## Observations and Scrutiny of Material considerations

S22-0538 Planning Application by Agri-Linc Holdings Ltd

Concessions By Applicant

S22/0538 The illustrative sheep grazing relative to Manor Road rear gardens Note; the 'Green shed' B1 will be removed

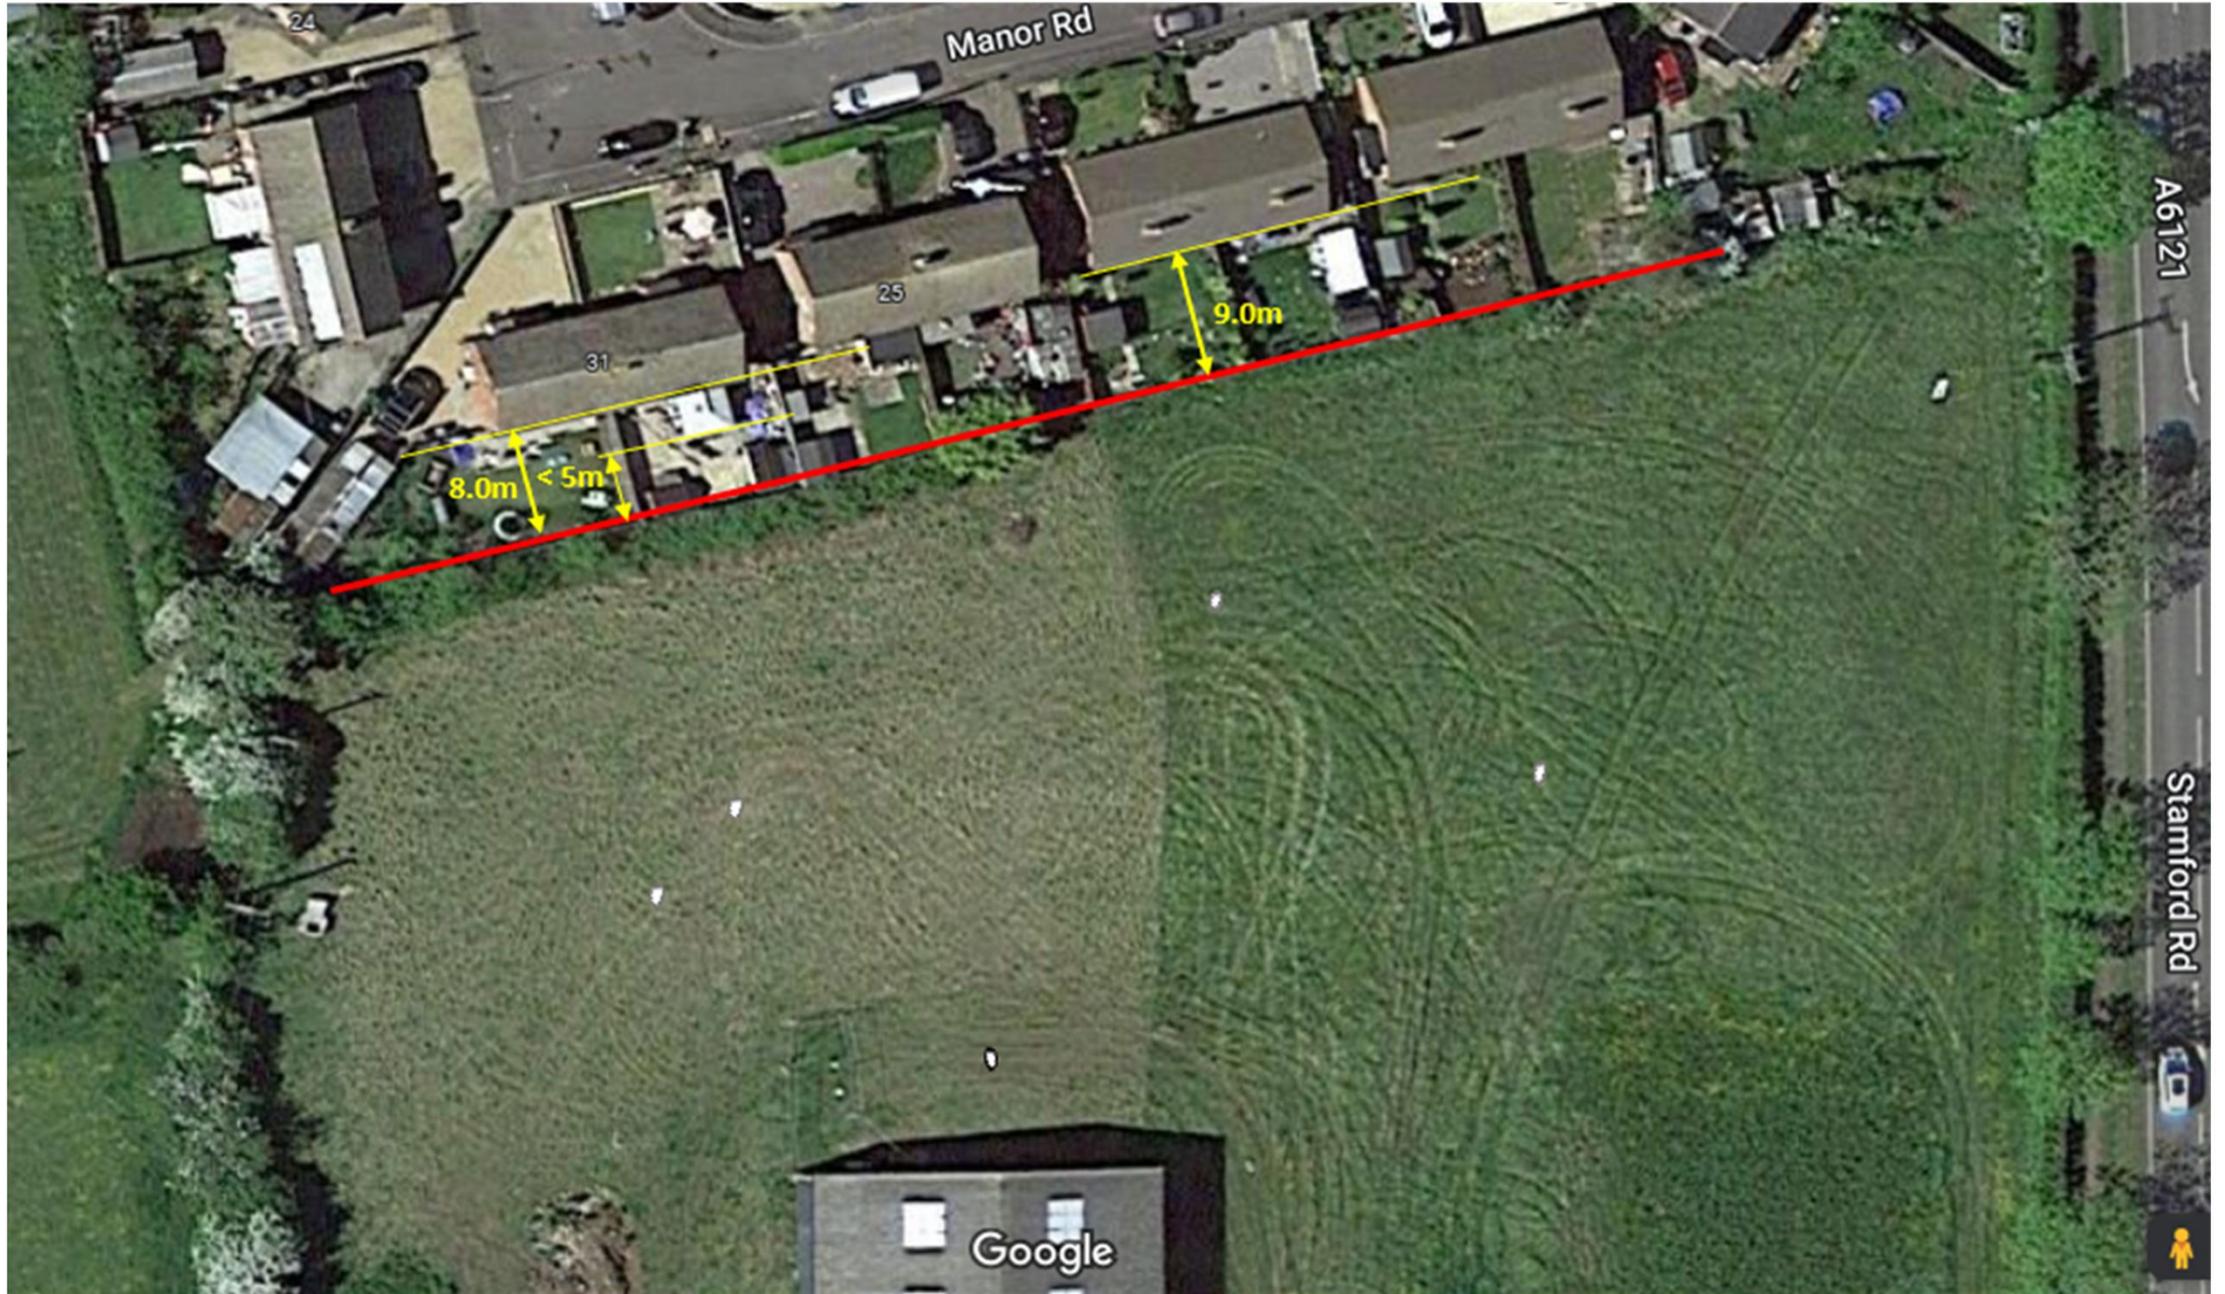
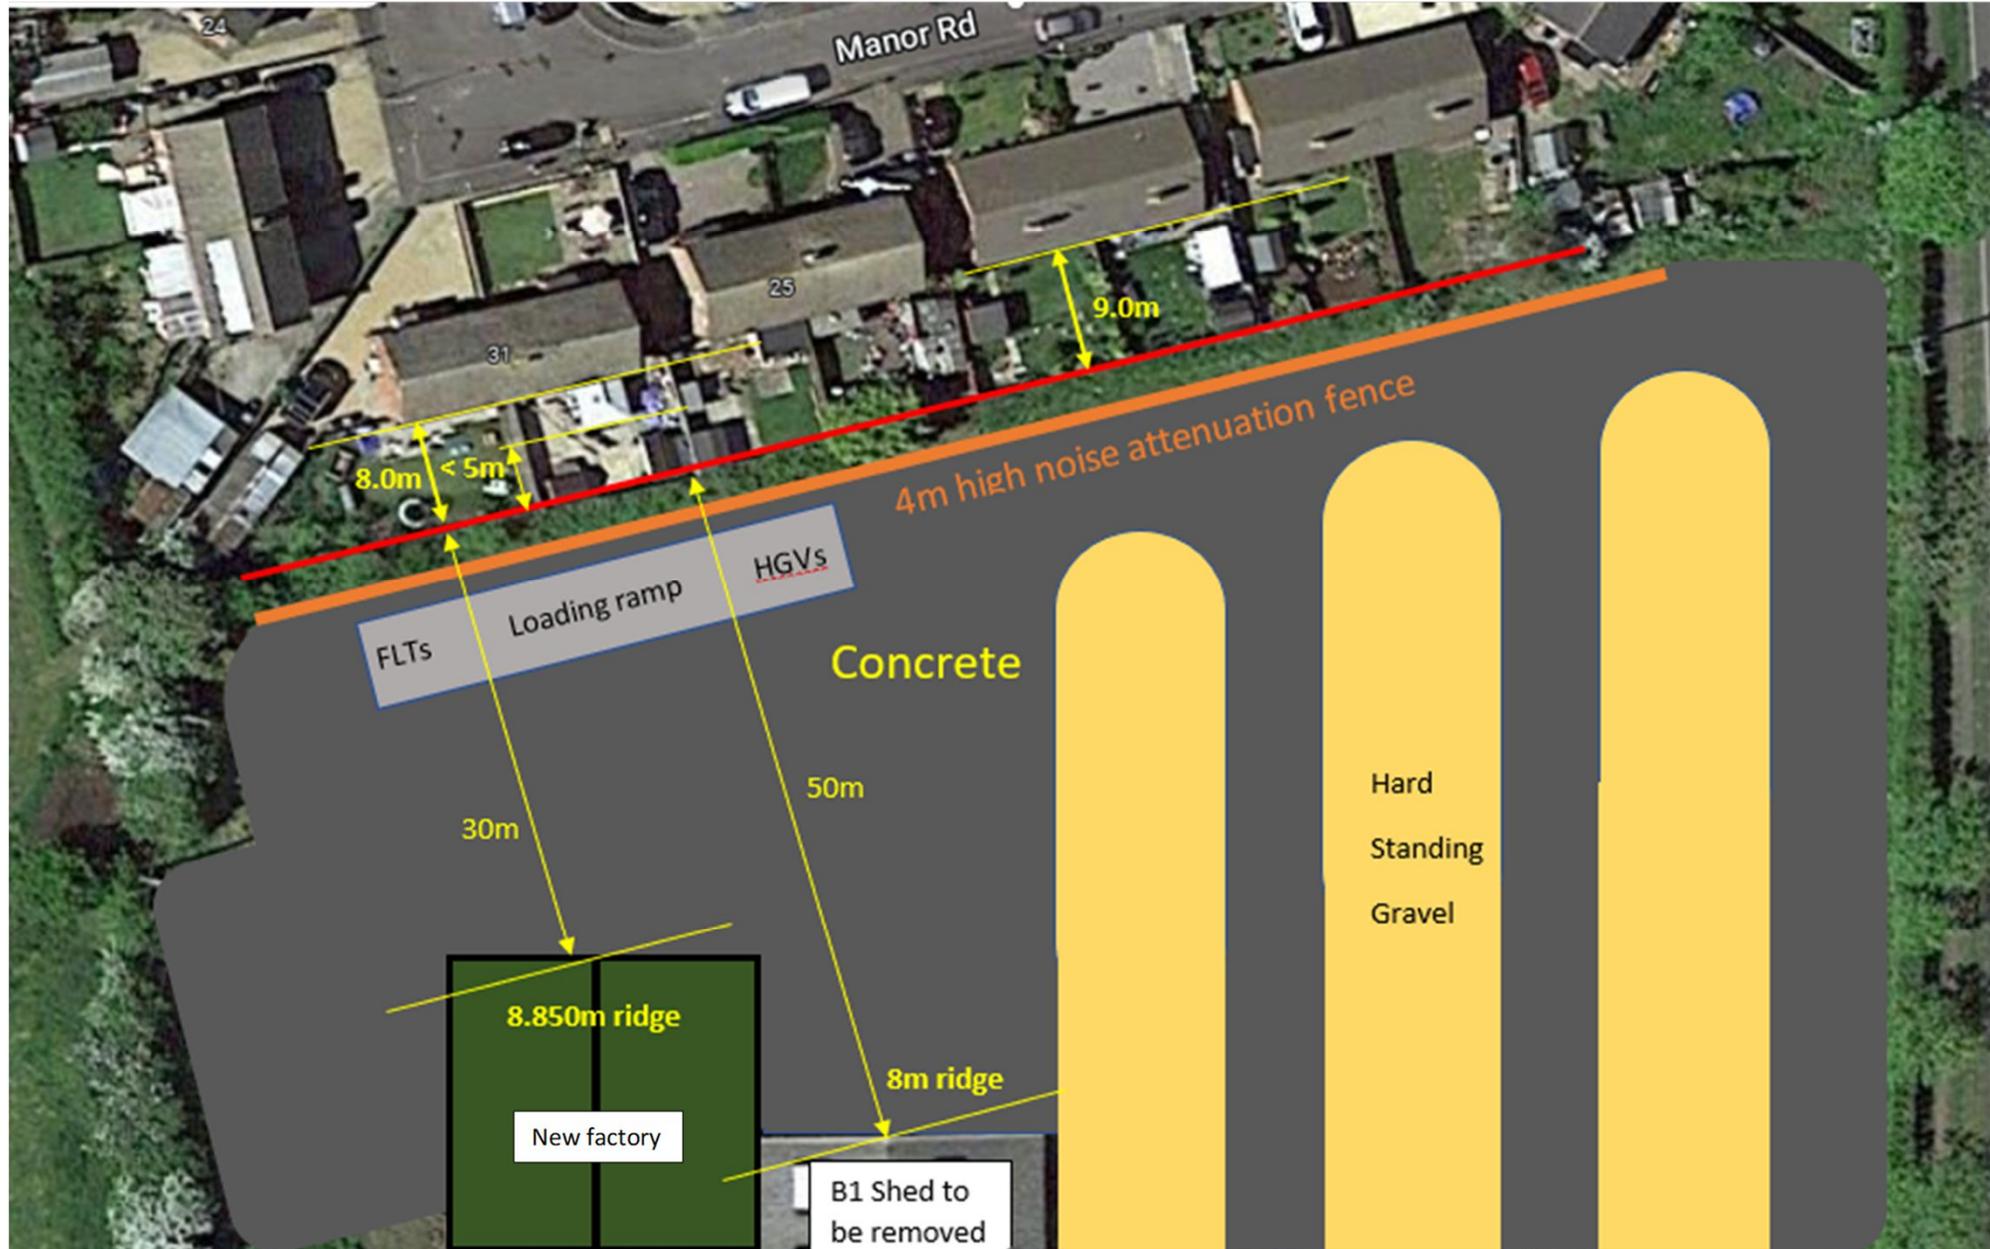
'Comment on this application' due to the impact (simulation to scale) on the amenity of the view
